Service information

Exhaust grille is hard to mount

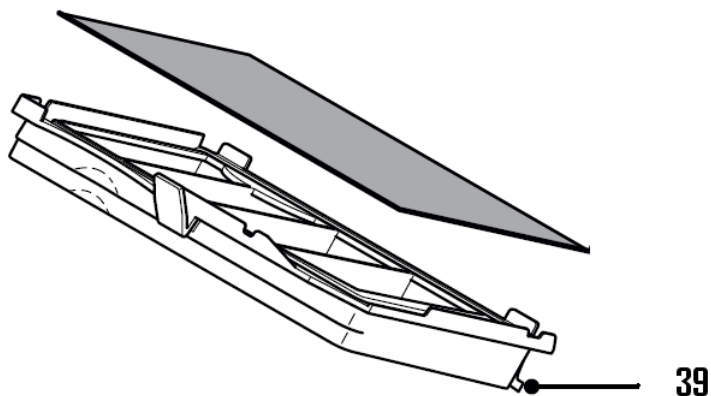
INFO: After some complaints it was found that due to too much sealing material used in the AFS filter support (Pos.39) there is too much tension on the Exhaust grille, causing it to pop out

CURE: Please replace AFS support 432200518070, this should solve the problem. (PS. problem will also solve itself, after some use/heating up the sealing will adjust itself) Optional soluti
